DEPARTMENT REPORT

HEARING DATE: August 6, 2026

FROM: Sonya Allen, Associate Planner
208-884-5533
sallen@meridiancity.org

SUBJECT: H-2025-0007
Syringa Crossing Mixed-Use Development (aka Hawkins Syringa Crossing Subdivision) – AZ, CUP, PP

FA3. Mixed Use Community Concept Color Diagram with Markup

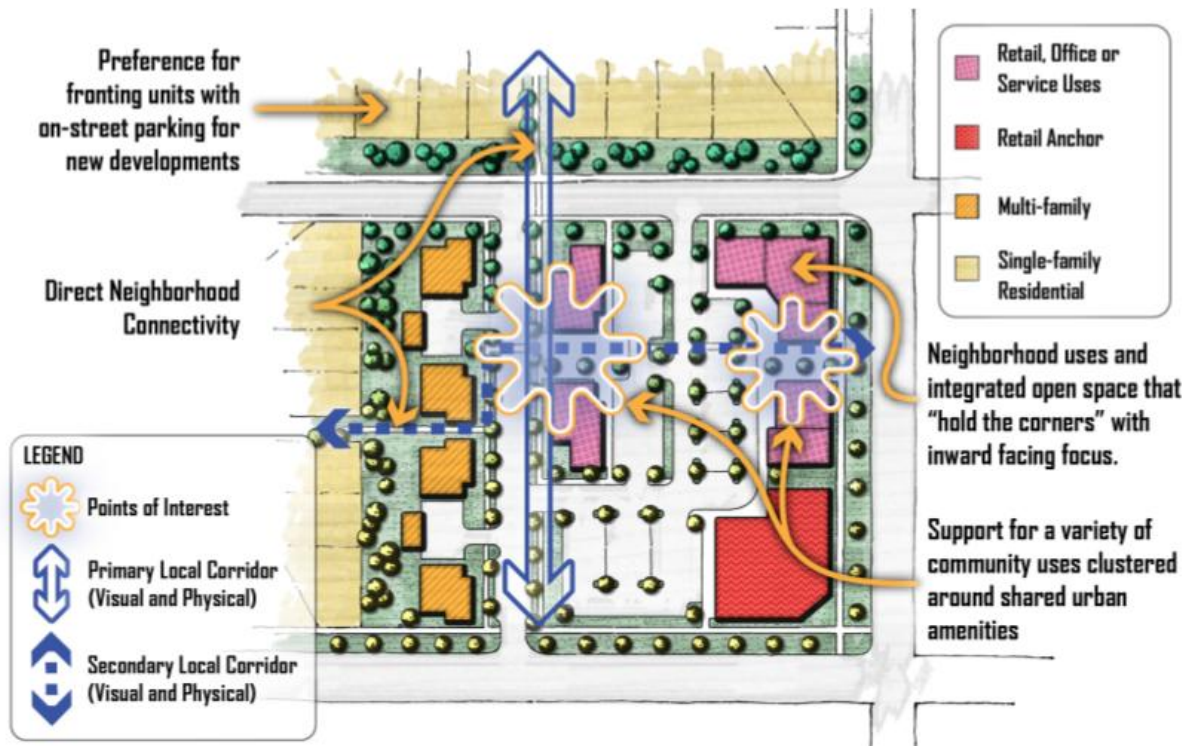
Development review for consistency with the Comprehensive Plan will consider the integration of use and holistic design sub-sections (below) in all mixed-use areas unless otherwise noted. To be successful, the principles outlined must be considered as interrelated features serving the basis of plan design. **Contiguous Mixed Use identified areas that are bisected by an arterial or highway are considered separate and independent areas for use and design integration and will be evaluated independently of each other per the Plan (pp. 3-14 & 3-16).**

E. Conceptual Development Plan for Annexation Area (dated: 5/29/26)

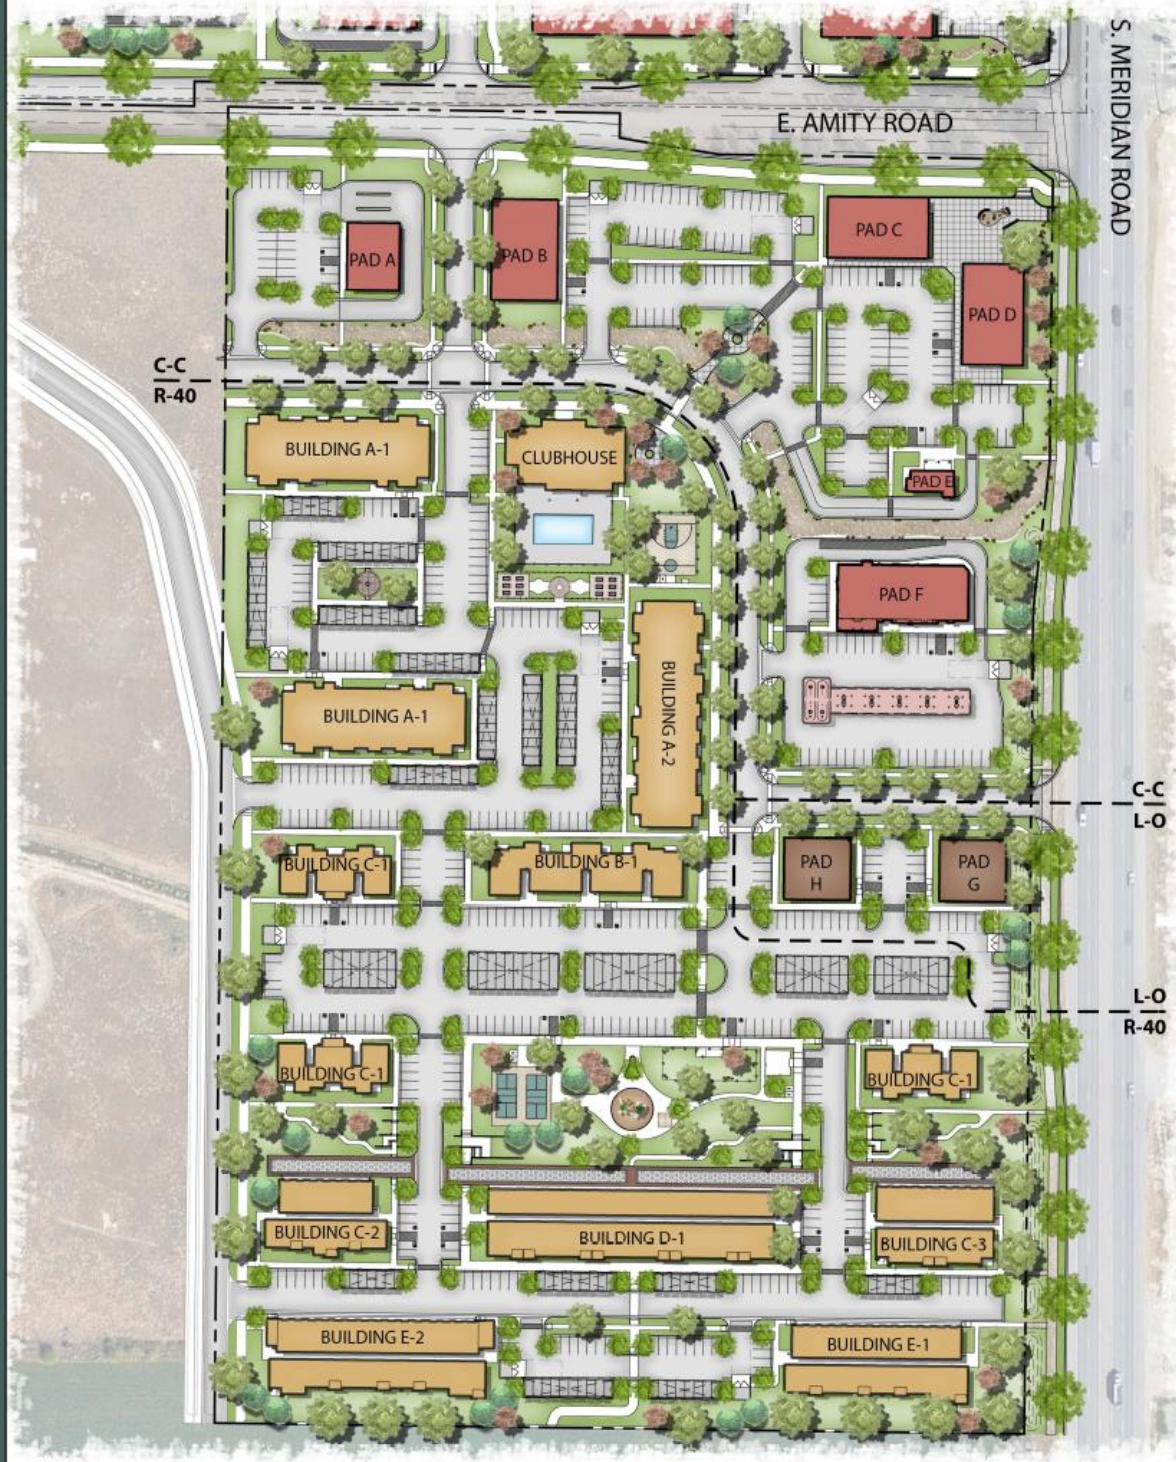
Based on the above-noted general mixed-use and MU-C design principles and analysis, Staff does not find the proposed development plan is consistent with the Comprehensive Plan and therefore, cannot provide a recommendation of approval on the annexation request and consequently the preliminary plat and conditional use permit requests.

- **The conceptual development plan for the SWC of the development should be revised to reflect residential uses comprising between 20% and 50% of the development area with gross densities ranging from 6 to 15 units/acre (of the residential area). *Currently, 72% of the 24.47-acre site is residential at a gross density of 18.24 units per acre.***

The access points depicted on the conceptual development plan are not approved and should be evaluated with a future subdivision application.

- **If the NWC property is annexed, the conceptual development plan for that development should be revised to include driveway(s) accesses to the out-parcels (#R4622730010, #S1225449220 & #S1225449910) along S. Meridian Rd./SH-69 that currently take access via S. Meridian Rd./SH-69 for internal access from within the site.**
